Planning Board – Monday, October 26, 2020, 6:30PM

SPR-18-14, Modification #1 – SITE PLAN REVIEW – 166 West Street

166 WEST STREET REDEVELOPMENT

C-1

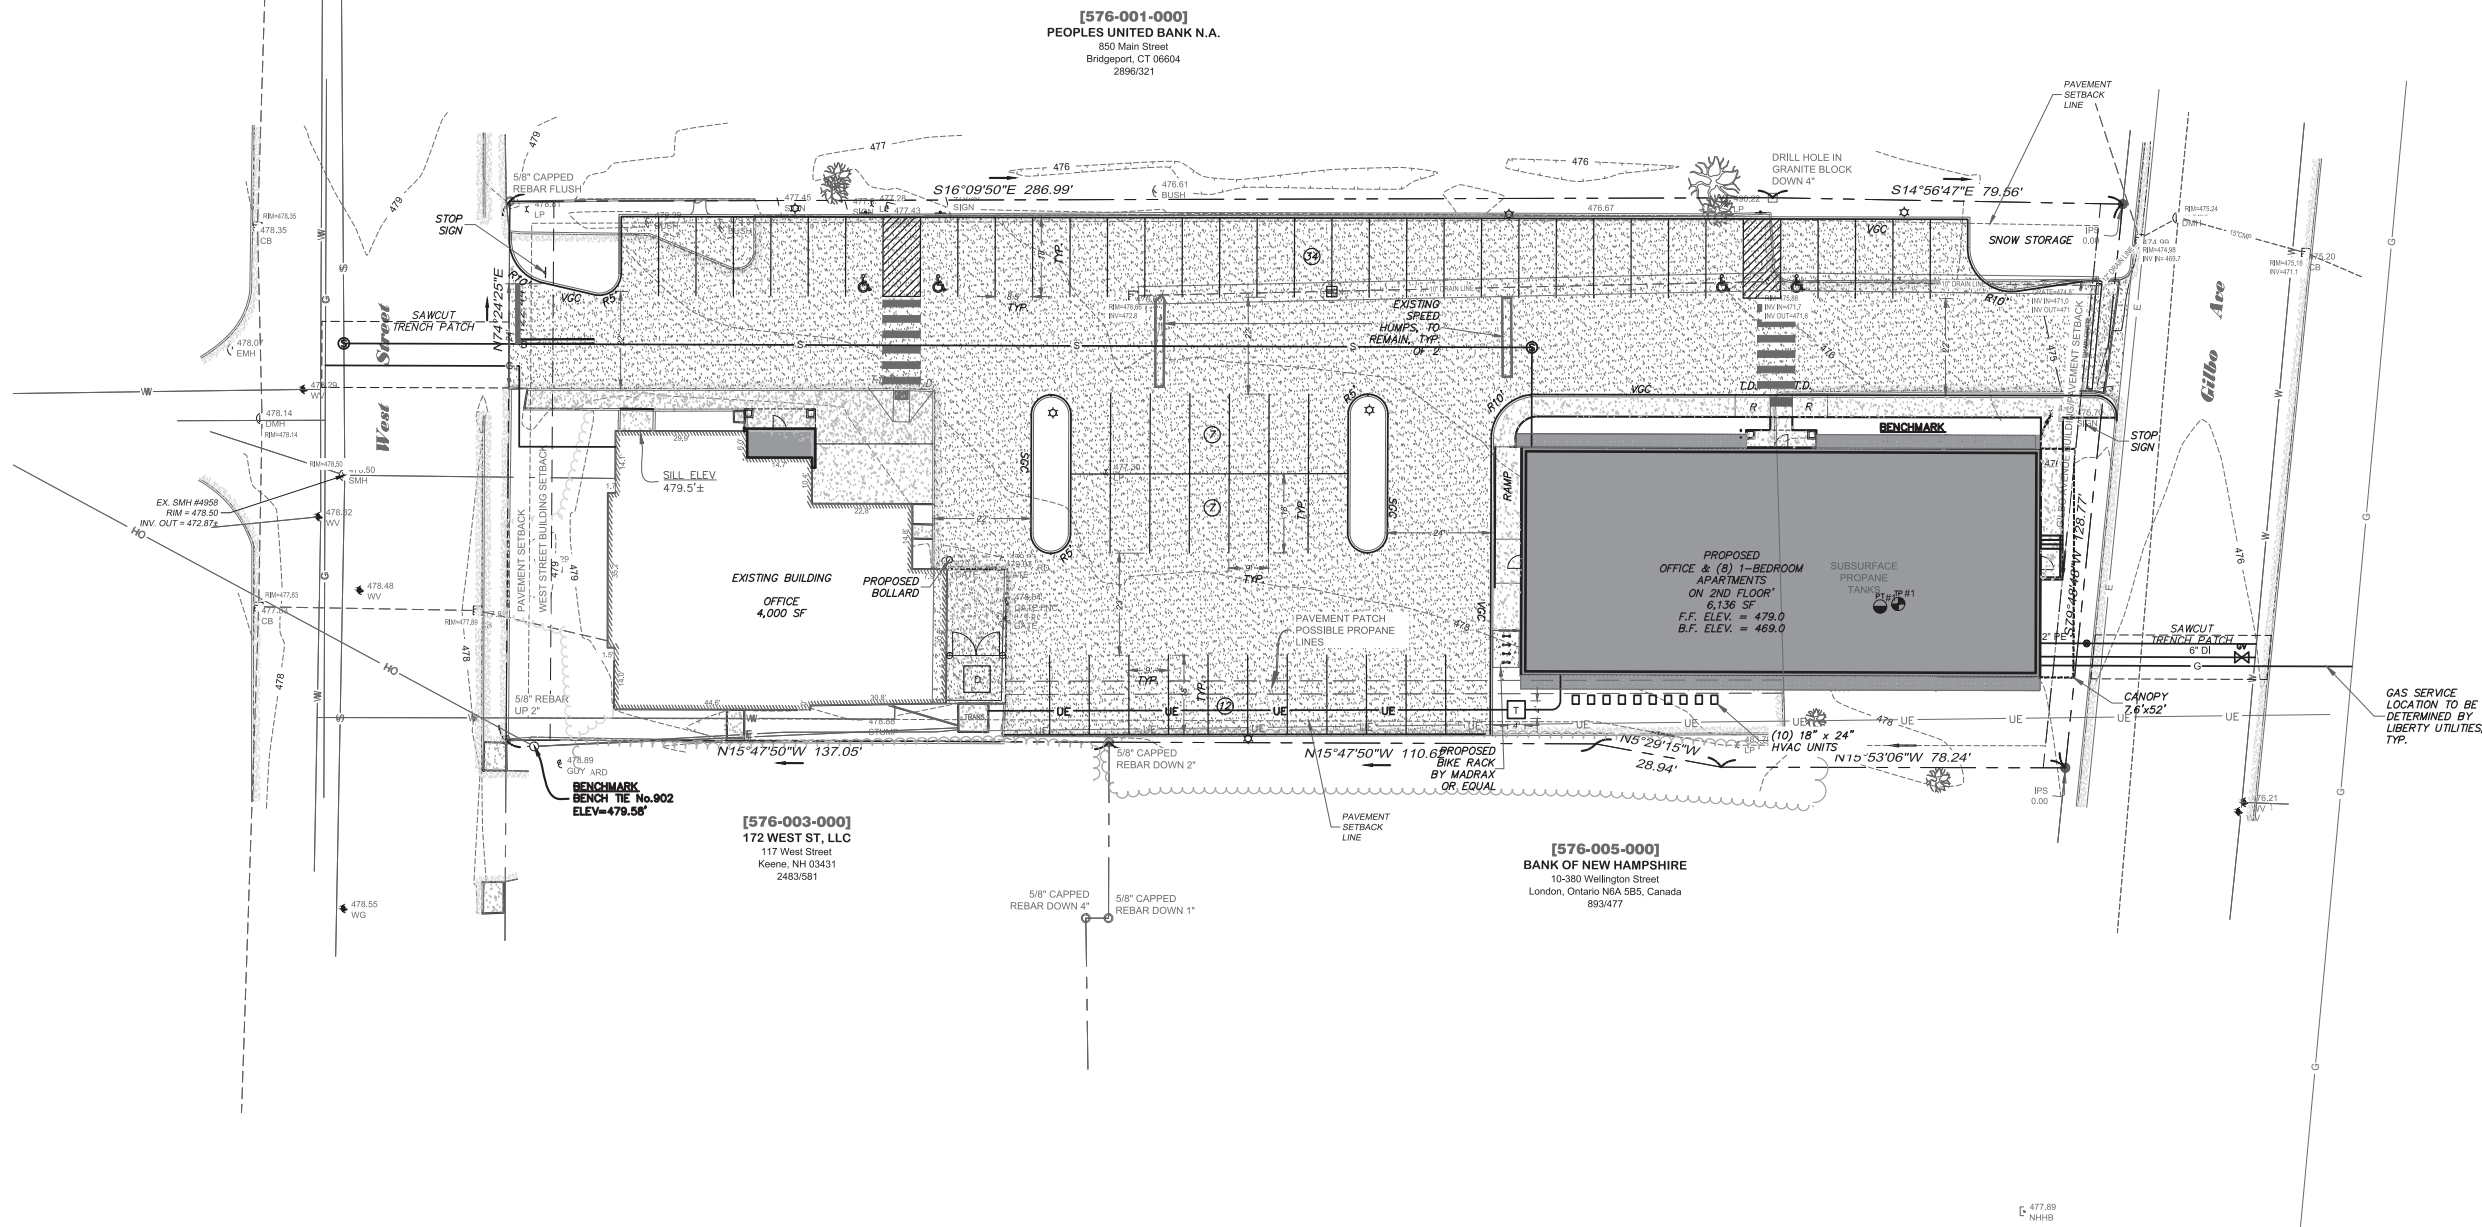
- **Fire:** No comments
- **Code Enforcement:**
 1. The Applicant must provide detectible warning strips at the crosswalk for the new building.
- **Police:** No comments
- **Engineering:**
 1. Please show the location of the temporary construction entrance into the site.
 2. Please provide separate service connections for domestic and fire lines (Sheet #C-1).

C-4

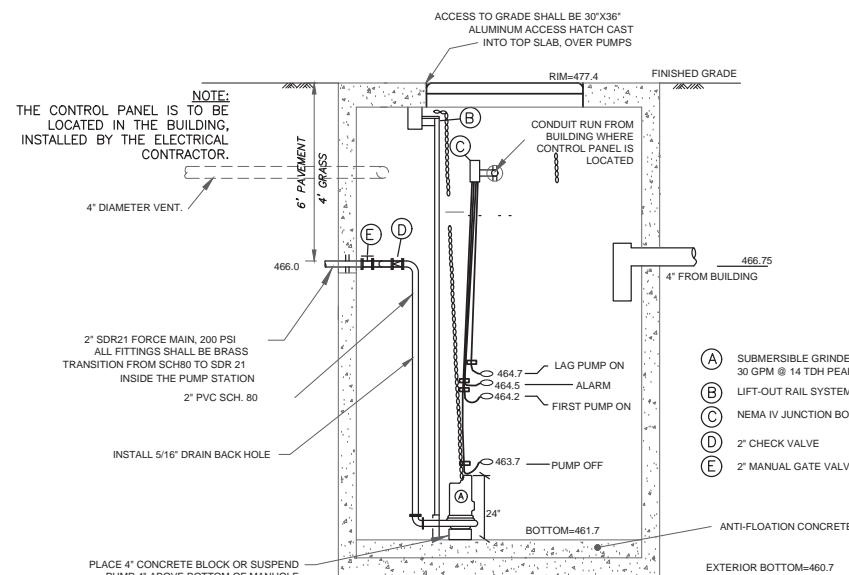
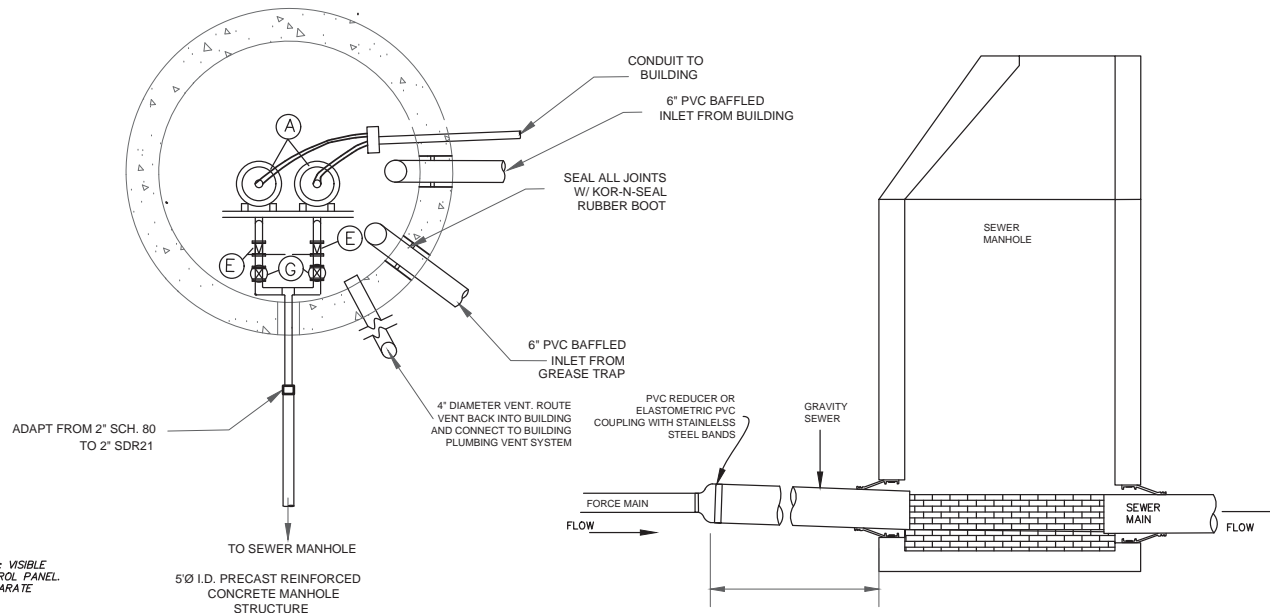
11. Sewer and Water: The Applicant proposes a new sewer line to connect the proposed new building to the sewer line in West Street. The Applicant submitted a sewer plan and sewer details (Sheets C-4 and C-5) to show the location and size of the proposed sewer line, which will be a two inch force main connected to a sewer pump. Engineering staff have reviewed the sewer discharge calculations and do not have any concerns about the capacity of the existing sewer line on West Street.

LIGHTING PLAN
 166 WEST STREET
 FLYBOY REALTY LLC
 P.O. BOX 1060
 KEENE, NEW HAMPSHIRE

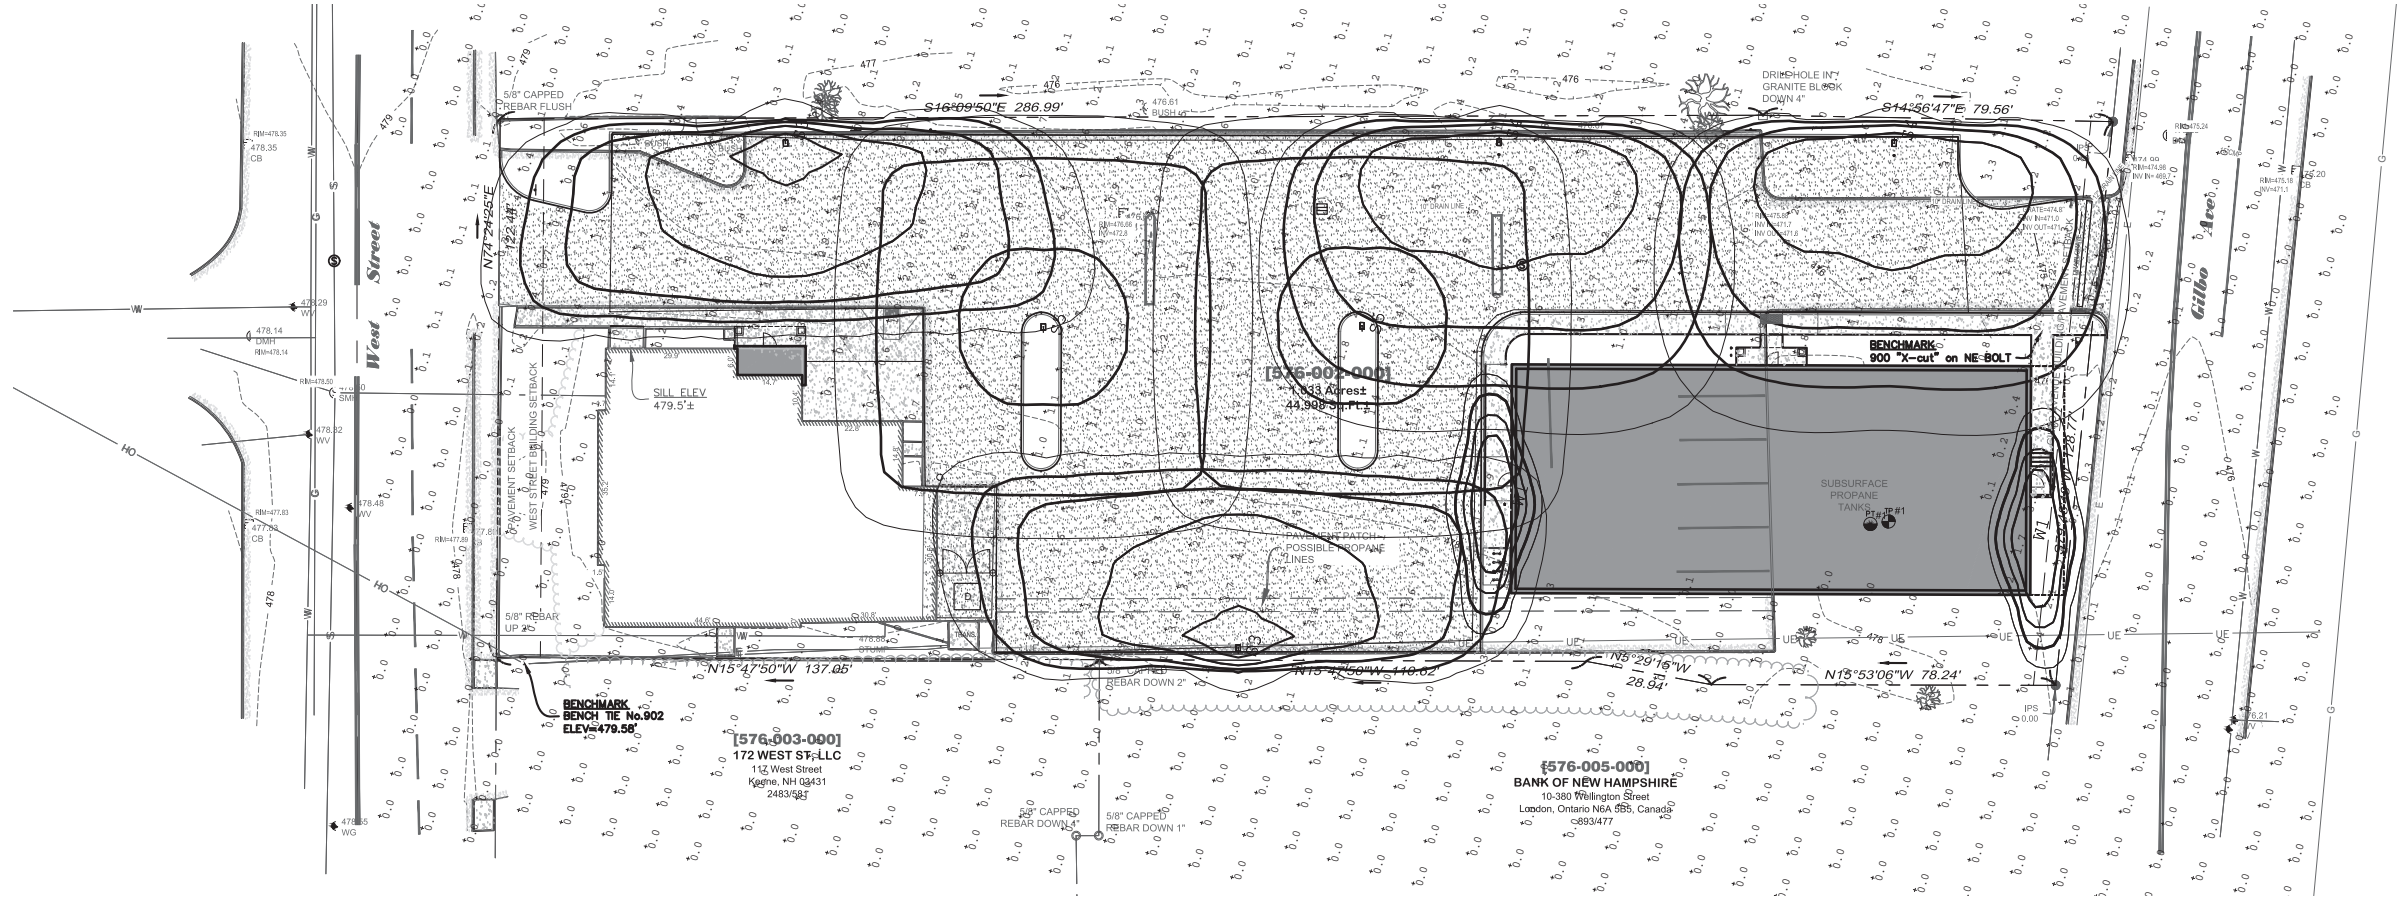
The Applicant has submitted light fixture cut sheets, which are attached to this staff report, as well as a lighting plan to show illumination levels for the parking lot area. According to this plan (Sheet LT-1), the average illumination will be 1.93 foot-candles (fc), which is between the acceptable values for a medium activity level parking lot (2.4 fc average) and a low activity level parking lot (0.8 fc average), and the minimum illumination levels will be 0.6 fc, which is consistent with the acceptable levels for a medium activity level parking lot. The uniformity ratio is 3.22, which is less than the required 4:1 ratio. The proposed use for this lot, which includes an office building and a mixed-use building with office space on the ground floor and apartments on the second floor, suggests that the activity level for the parking lot would be classified as “medium.”

DESIGN: LPS
 DRAWN: LPS
 CHECKED: RL
 PROJ. #: K2699
 DATE: 21-AUG-20
 SHEET
 41 of 48 **T-1**

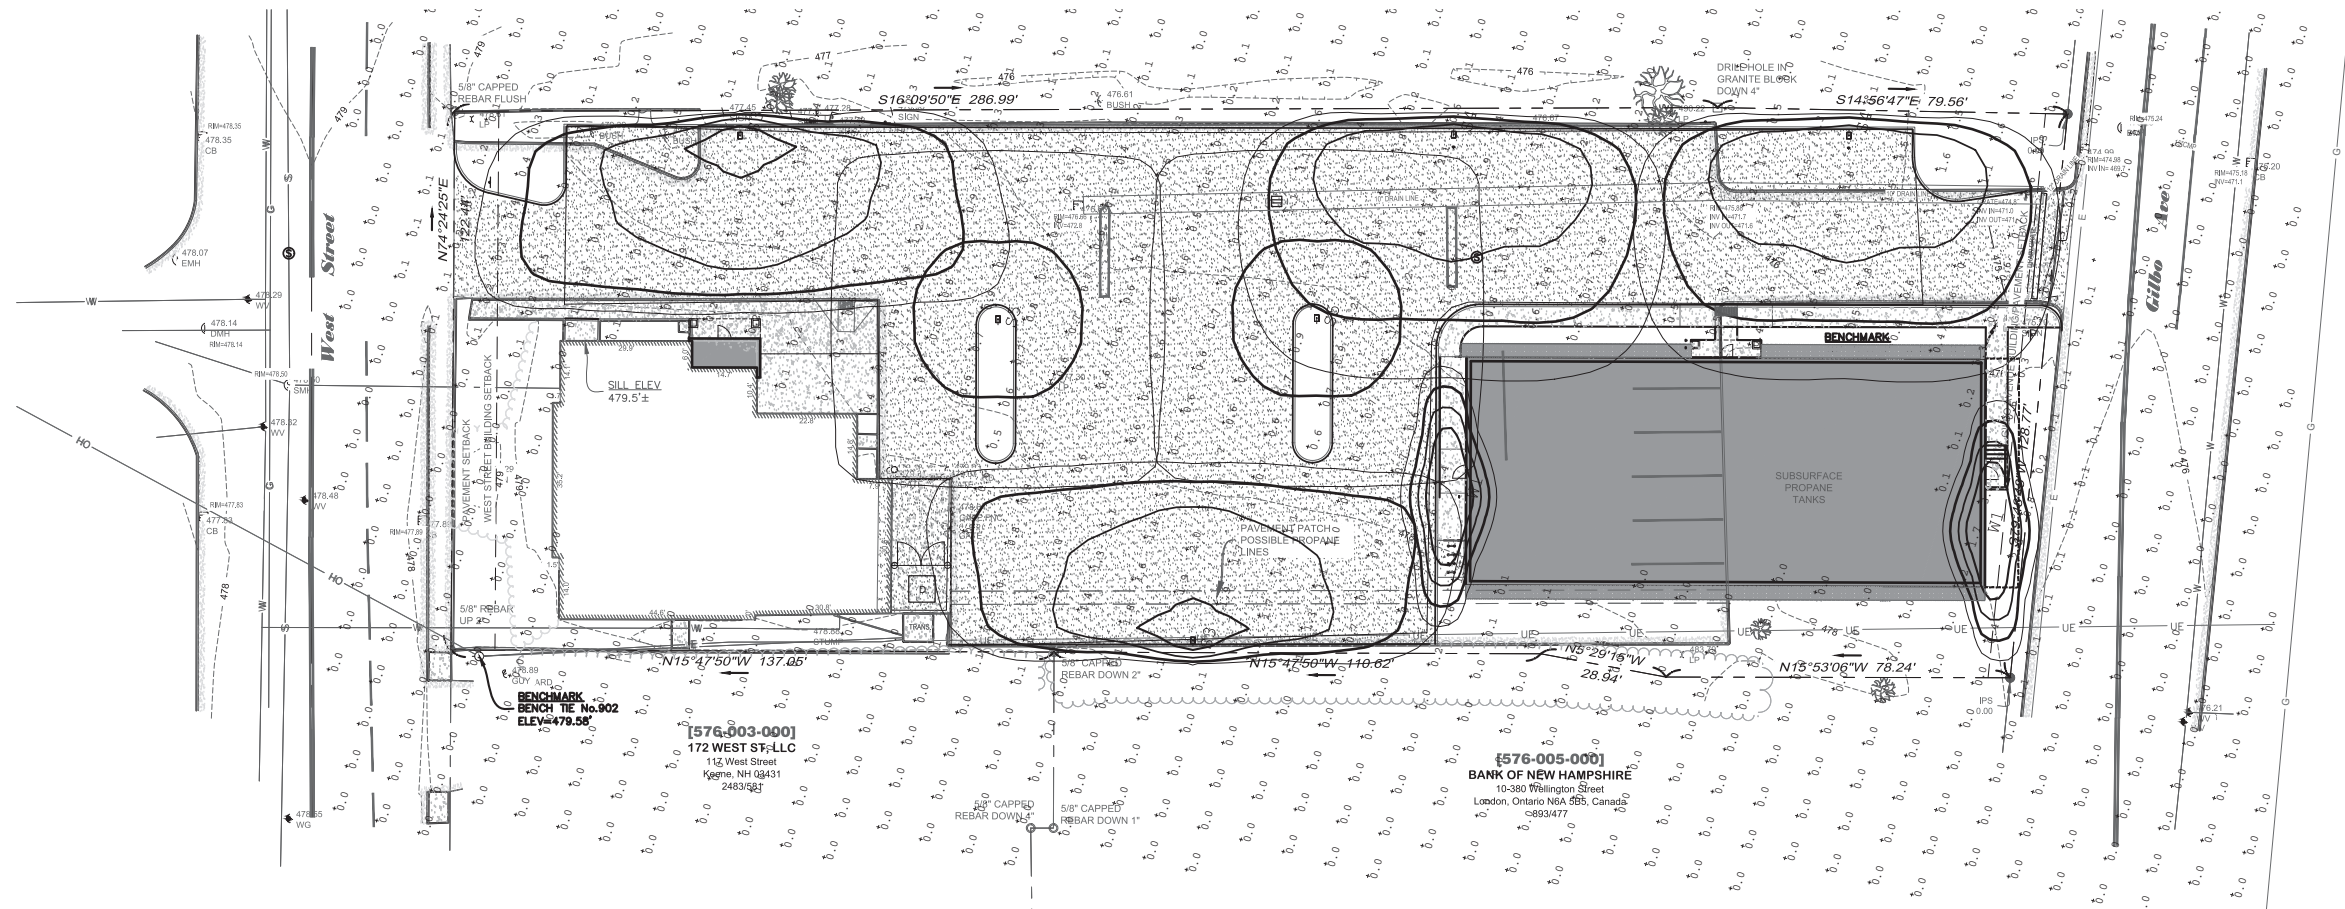
In addition, the Applicant submitted a reduced lighting plan (Sheet LT-2) to show illumination levels on the site after 10:00 pm when light levels are reduced by 50%. This plan indicates that the average illumination levels for the reduced lighting would be 0.97-fc. Per sub-section C.6.a. of this standard, the average illumination levels between 10:00 pm and 6:00 am shall not exceed 0.5-fc. The Applicant is aware of this issue, and indicated to staff that a revised plan will be submitted which complies with this standard. Staff recommend that the submission of a revised reduced lighting plan to show average illumination levels that do not exceed 0.5-fc be included as a condition of approval.

- 1. Submittal of a revised “Reduced Lighting Plan” which demonstrates that average illumination levels on the site will not exceed 0.5-fc between the hours 10:00 pm and 6:00 am.**
- 2. Owner’s signature appears on plan.**
